Re: Bus Connects Templeogue/Rathfarnham to City Centre Core Bus Corridor Scheme
Templeogue/Rathfarnham to City Centre

Bus Connects Submission to An Bord Pleanála in respect of the Templeogue/Rathfarnham to City Centre Core Bus Corridor

Bord Pleanála Case Reference: HA29N.316272

Written By Prof James Dwan, *PhD, M. Eng. Des., B. Eng. (Matl), B. Eng. (Mar), P. Grad. Dip. Stats., Eur Ing., CEng, FIEI.FIMMM, MWeldl.*
Chartered Engineer

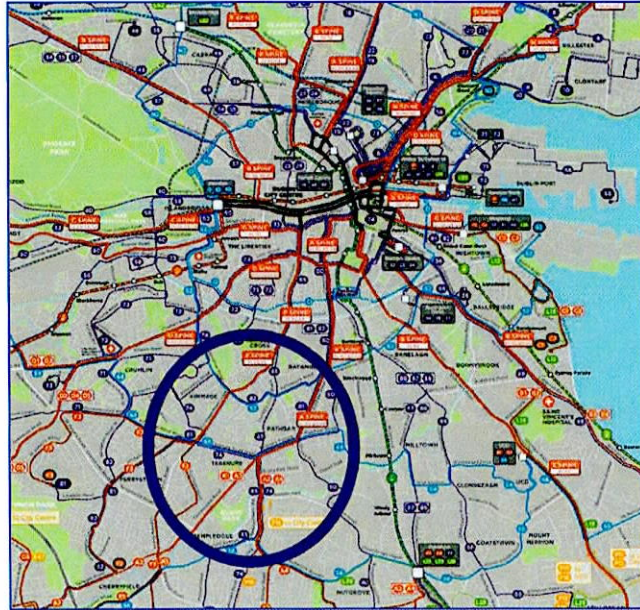
“... Bus infrastructure on this key access corridor in the Dublin region, which will enable and deliver efficient, safe, and integrated sustainable transport movement along the corridor”

A key issue with this statement of the NTA objective is that while it may well deliver bus infrastructure along the corridor, the reality of which is disputable, and perhaps it delivers integrated sustainable transport movement along the corridor, it does so at a significant cost to all other transport movement in the peripheral road network surrounding the corridor.

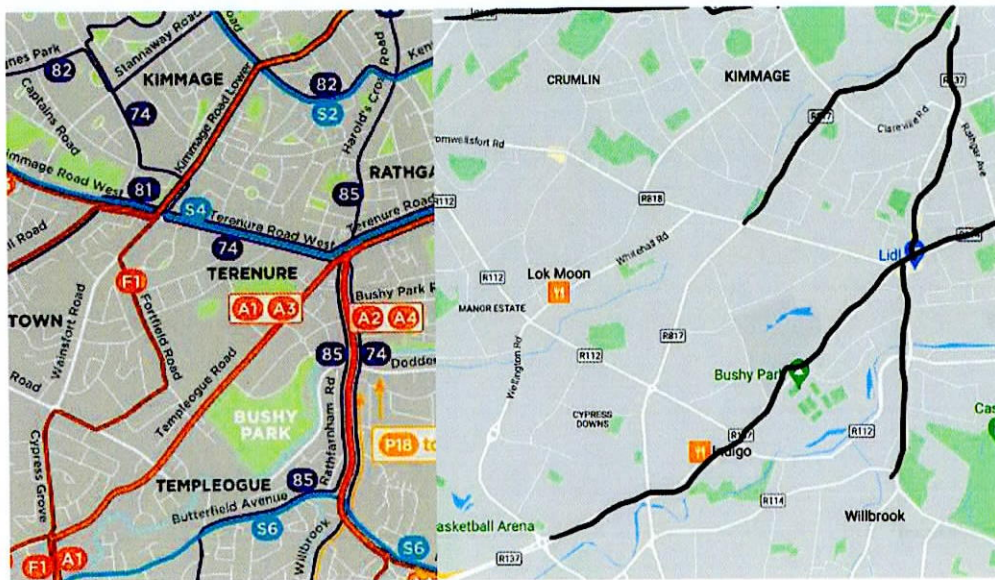
The map with the F1 bus route shown below on Cypress Grove Road and Fortfield Road, shows the only viable alternative for access to the city centre, hospitals, etc for that area and it will be accompanied by all of the traffic that is diverted from the Bus Corridor under consideration and it will be limited by the Kimmage Bus Corridor, where the red line for the F1 thickens. As the surrounding roads are either not accessible at all because of a bus gate, or barred from access due to the implementation of a ban on right hand turns, this route will be overpopulated with traffic, and yet this is a significantly increased bus route. This might be bearable if it were during rush hour/peak traffic times only, but it isn't – it's from 6am to 8pm every day of the week. The timing of the bus gate is nonsensical and an unnecessary diminution of the quality of life of the residents in that area. Residents will have to drive much longer routes to gain access and egress from their roads and to access hospitals, doctors, dentists, schools and shopping areas.

Meanwhile the 54A bus route as it was, proposed now as the F1, will be removed from its route along Templeville Road, a cause of much distress to elderly residents on Grosvenor Court off Templeville Road, who until now have ease of access to this bus route but under new plans will have to walk a considerable distance. This bus route will no longer travel the road outside Templeogue College, removing that direct connectivity up to a road running perpendicular to Templeville Road. Its route

along the section of Templeville Road it traverses, Fortfield Park where there are two schools St Pius X boys and St Pius X girls national schools, Fortfield Road where there is Terenure College as well as the drop off for Our Lady's School on Templeogue Road and now no right hand turns into Greenlea Road or Lavarna Grove, will be clogged with the traffic that would have otherwise been able to travel along Templeogue Road. The traffic surveys carried out show that up to 7,404 vehicles that currently use Templeogue Road 300 of which is lorries, will be prohibited from so doing due to the bus gate. 1,440 vehicles will remain on Fortfield Road as they will be prohibited from going down Greenlea Road – that is how many vehicles will be trying to turn right towards the KCR now and causing that backlog of traffic. That is a considerable displacement from those two roads alone that will now be using the route alongside the F1 bus route. This alone demonstrates that the objective as set out will not be achieved for this section of road.
